Town of Kittery Planning Board Meeting September 14, 2023

ITEM 3—27 & 29 Wentworth—Site Plan — Preliminary Review

Action: accept site plan as complete. Schedule site walk/public hearing. Eric Weinreb, on behalf of applicant Madbury Real Estate Ventures, is proposing to convert an existing bed and breakfast into two independent inns with a total of 12 rental units each and a single innkeeper's suite. The proposed development is located on the properties of 27 & 29 Wentworth Street, Map 9 Lots 37, 38, in the Kittery Foreside (MU-KF) Zone.

STORMWATER MGMT. PLAN

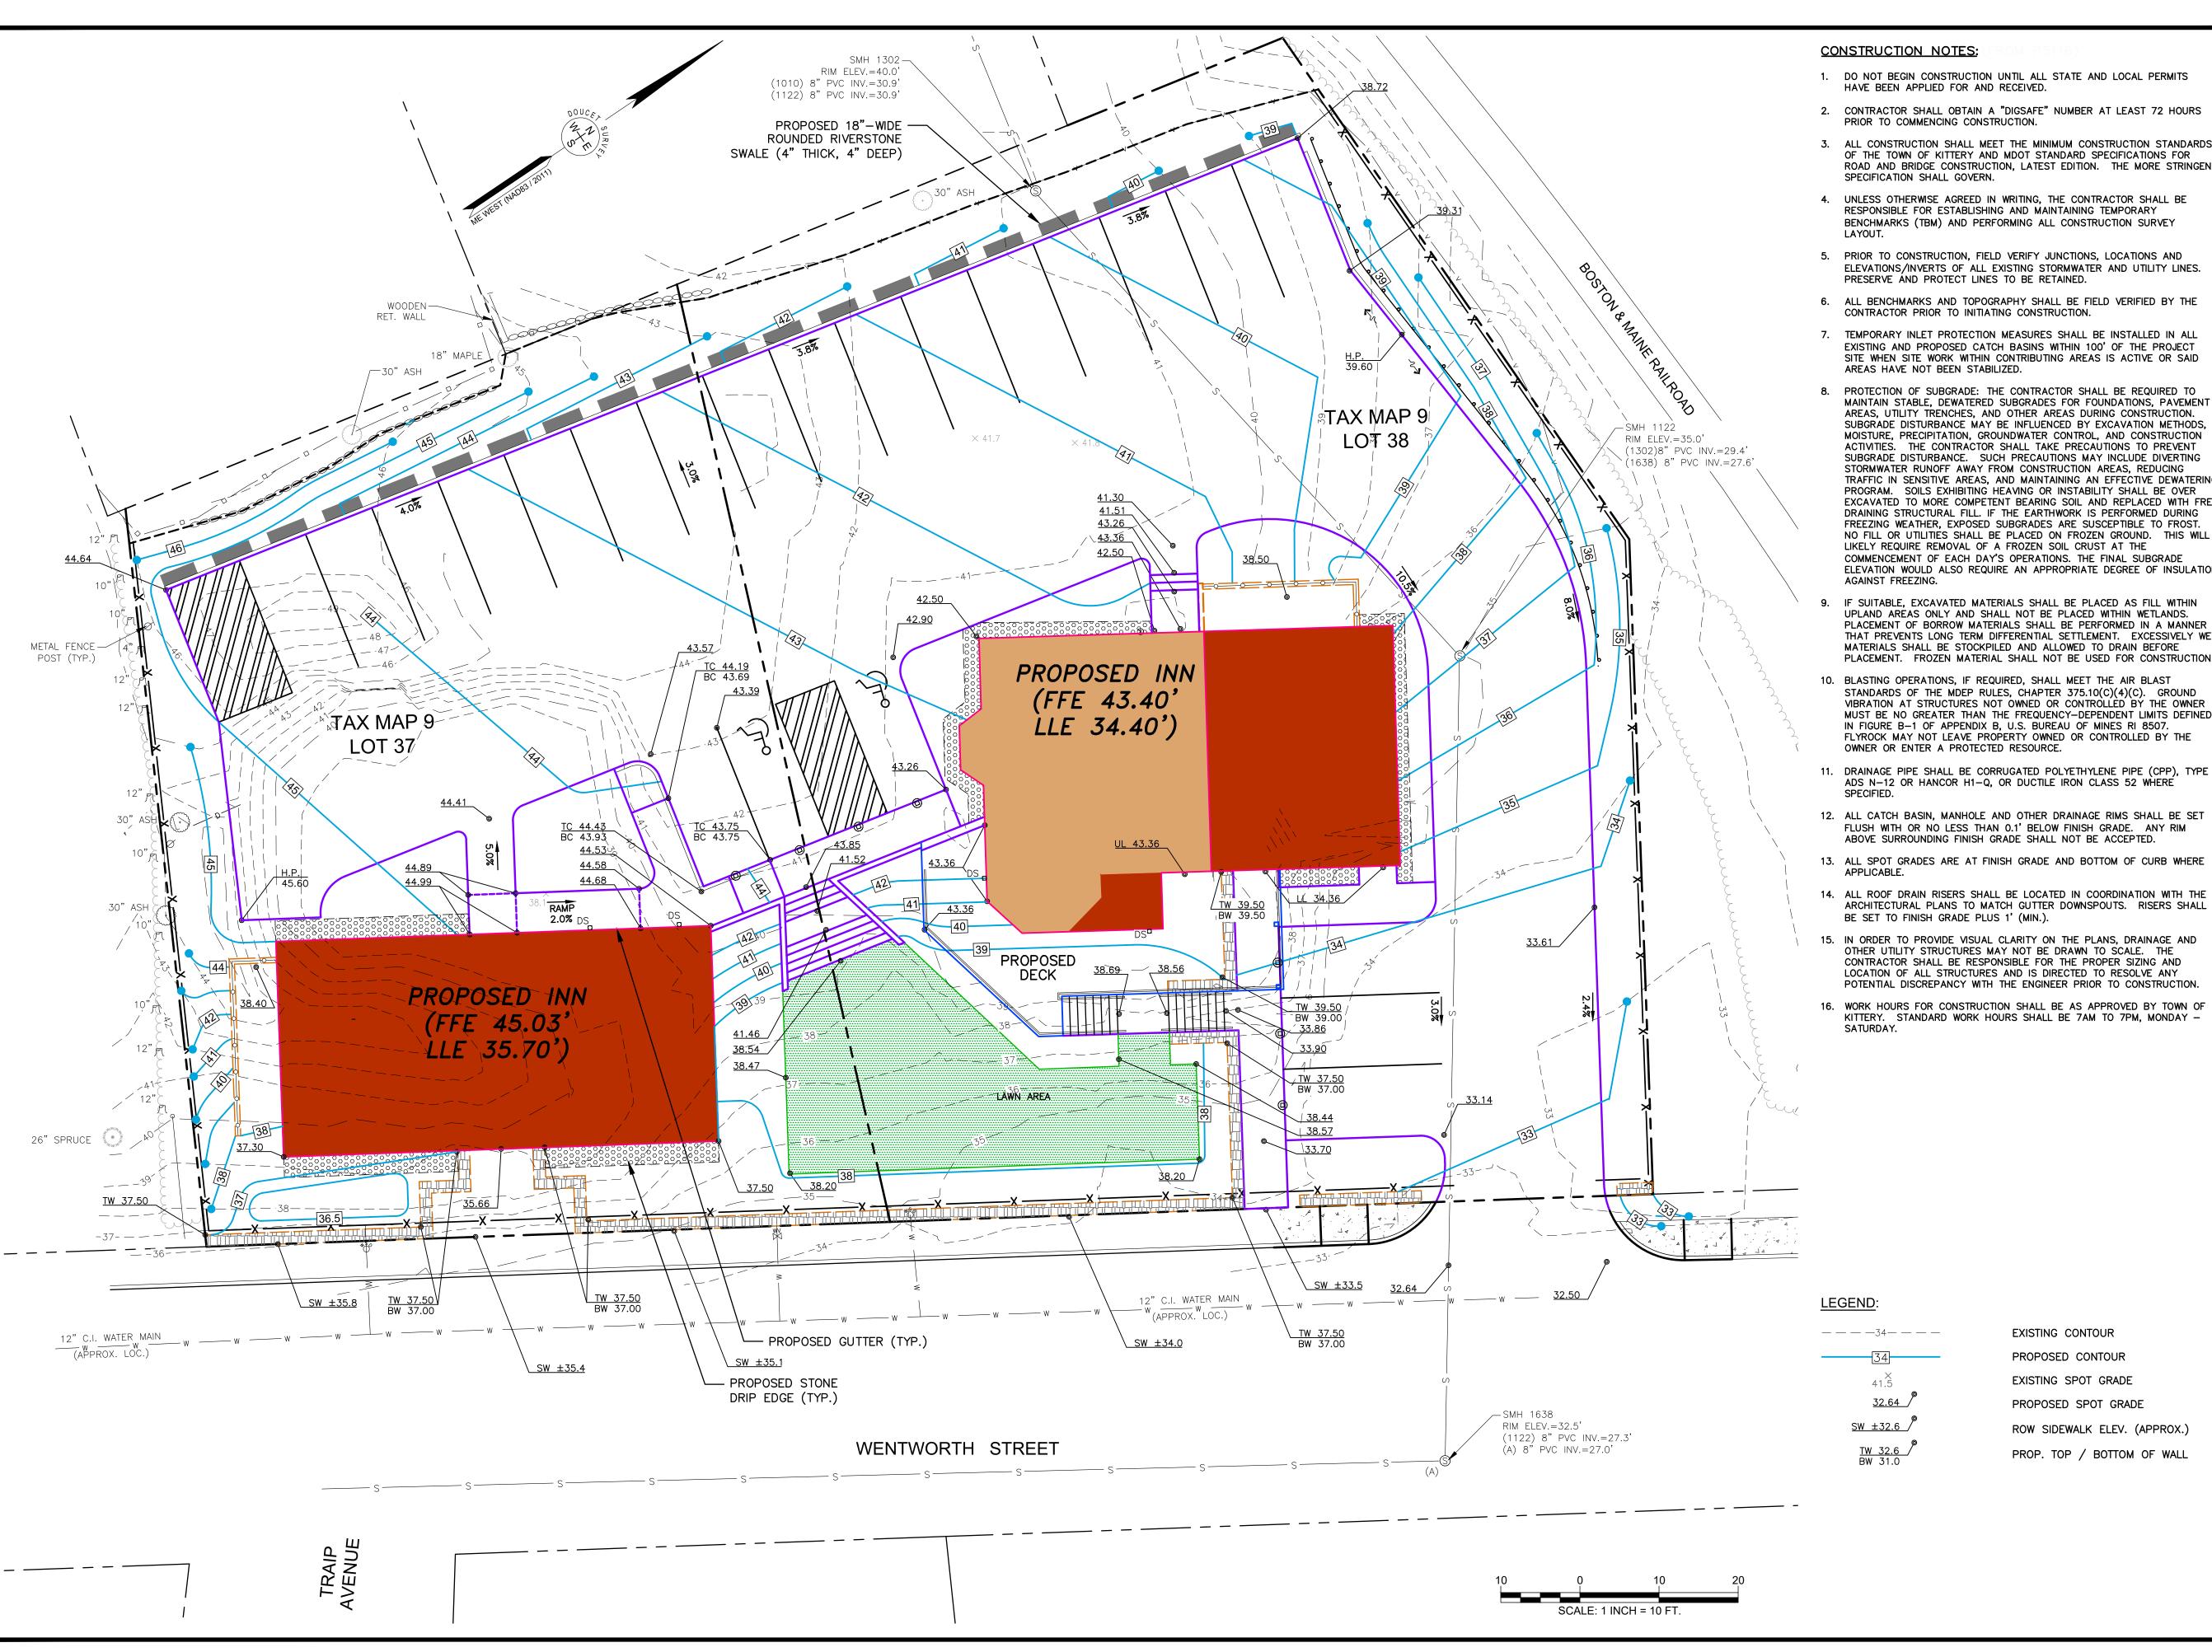
- a. Planning staff suggest the property descriptions in the easement contain the map/lot property identifiers.
- 3. The stormwater management plan appears to show drainage off the property into the adjacent railroad area. When asked, the applicant stated they were planning to mimic existing conditions, but public works staff would like to see the proposal eliminate off-site drainage entirely.

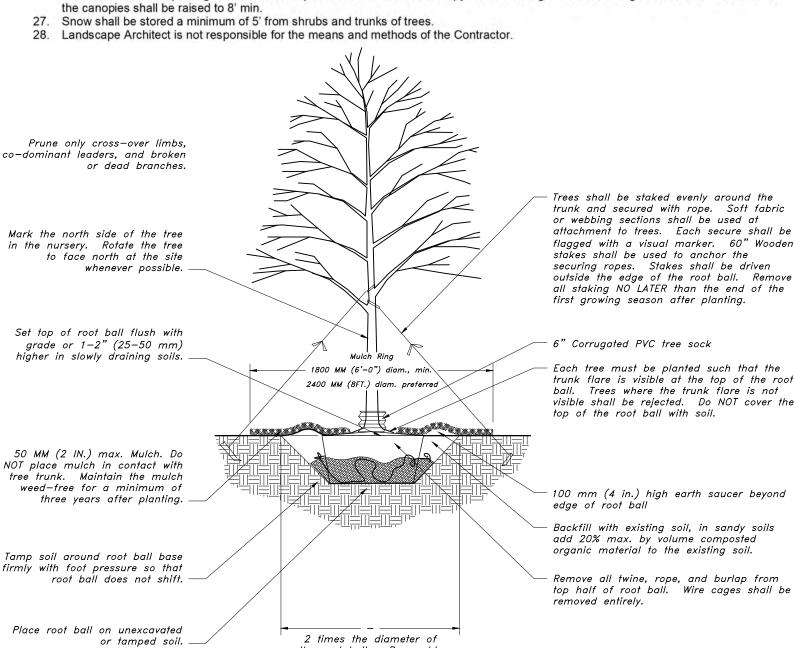
- 6. On the landscape plan, the trees with solid circles in the center are proposed to remain, while the trees with pluses will be removed.
 - a. Staff suggest removing Japanese Tree Lilac from the plant list, as they are considered non-native to Maine.
